PRODUCT
CHANGE NOTIFICATION

EE Series Photomicrosensor Packaging Change

EE SERIES PHOTOMICROSENSOR PACKAGE CHANGE

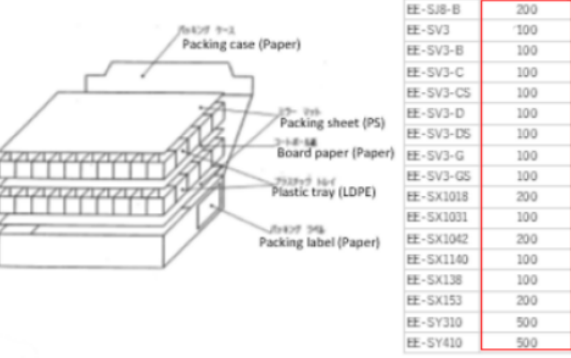
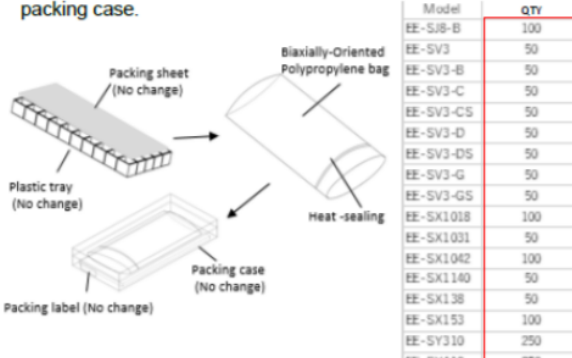
Before the change	After the change																																																																								
<p>Packing: EE-SX1041 Four polyethylene bags containing the sensor are packed in a packing case.</p>  <p>polyethylene bag Packing case Packing label (No change)</p> <table><thead><tr><th>Model</th><th>QTY</th></tr></thead><tbody><tr><td>EE-SX1041</td><td>2000</td></tr></tbody></table>	Model	QTY	EE-SX1041	2000	<p>Packing: EE-SX1041 A Biaxially-Oriented Polypropylene bag containing the sensor is thermally sealed. Pack 4 heat-sealed bags in a packing case.</p>  <p>Biaxially-Oriented Polypropylene bag Heat-sealing Packing case Packing label (No change)</p> <table><thead><tr><th>Model</th><th>QTY</th></tr></thead><tbody><tr><td>EE-SX1041</td><td>1600</td></tr></tbody></table>	Model	QTY	EE-SX1041	1600																																																																
Model	QTY

EE-SX1041	2000																																																																								
Model	QTY																																																																								
EE-SX1041	1600																																																																								
<p>Packing: EE Series Two plastic trays containing the sensor are packed in a packing case.</p>  <p>Packing case (Paper) Packing sheet (PS) Board paper (Paper) Plastic tray (LDPE) Packing label (Paper)</p> <table><thead><tr><th>Model</th><th>QTY</th></tr></thead><tbody><tr><td>EE-SJ8-B</td><td>200</td></tr><tr><td>EE-SV3</td><td>100</td></tr><tr><td>EE-SV3-B</td><td>100</td></tr><tr><td>EE-SV3-C</td><td>100</td></tr><tr><td>EE-SV3-CS</td><td>100</td></tr><tr><td>EE-SV3-D</td><td>100</td></tr><tr><td>EE-SV3-DS</td><td>100</td></tr><tr><td>EE-SV3-G</td><td>100</td></tr><tr><td>EE-SV3-GS</td><td>100</td></tr><tr><td>EE-SX1018</td><td>200</td></tr><tr><td>EE-SX1031</td><td>100</td></tr><tr><td>EE-SX1042</td><td>200</td></tr><tr><td>EE-SX1140</td><td>100</td></tr><tr><td>EE-SX138</td><td>100</td></tr><tr><td>EE-SX153</td><td>200</td></tr><tr><td>EE-SY310</td><td>500</td></tr><tr><td>EE-SY410</td><td>500</td></tr></tbody></table>	Model	QTY	EE-SJ8-B	200	EE-SV3	100	EE-SV3-B	100	EE-SV3-C	100	EE-SV3-CS	100	EE-SV3-D	100	EE-SV3-DS	100	EE-SV3-G	100	EE-SV3-GS	100	EE-SX1018	200	EE-SX1031	100	EE-SX1042	200	EE-SX1140	100	EE-SX138	100	EE-SX153	200	EE-SY310	500	EE-SY410	500	<p>Packing: EE Series Plastic tray containing the sensor is placed in a Biaxially-Oriented Polypropylene bag and heat-sealed. One layer of plastic trays heat-sealed with bags is packed in a packing case.</p>  <p>Packing sheet (No change) Plastic tray (No change) Heat-sealing Packing case (No change) Packing label (No change)</p> <table><thead><tr><th>Model</th><th>QTY</th></tr></thead><tbody><tr><td>EE-SJ8-B</td><td>100</td></tr><tr><td>EE-SV3</td><td>50</td></tr><tr><td>EE-SV3-B</td><td>50</td></tr><tr><td>EE-SV3-C</td><td>50</td></tr><tr><td>EE-SV3-CS</td><td>50</td></tr><tr><td>EE-SV3-D</td><td>50</td></tr><tr><td>EE-SV3-DS</td><td>50</td></tr><tr><td>EE-SV3-G</td><td>50</td></tr><tr><td>EE-SV3-GS</td><td>50</td></tr><tr><td>EE-SX1018</td><td>100</td></tr><tr><td>EE-SX1031</td><td>50</td></tr><tr><td>EE-SX1042</td><td>100</td></tr><tr><td>EE-SX1140</td><td>50</td></tr><tr><td>EE-SX138</td><td>50</td></tr><tr><td>EE-SX153</td><td>100</td></tr><tr><td>EE-SY310</td><td>250</td></tr><tr><td>EE-SY410</td><td>250</td></tr></tbody></table>	Model	QTY	EE-SJ8-B	100	EE-SV3	50	EE-SV3-B	50	EE-SV3-C	50	EE-SV3-CS	50	EE-SV3-D	50	EE-SV3-DS	50	EE-SV3-G	50	EE-SV3-GS	50	EE-SX1018	100	EE-SX1031	50	EE-SX1042	100	EE-SX1140	50	EE-SX138	50	EE-SX153	100	EE-SY310	250	EE-SY410	250
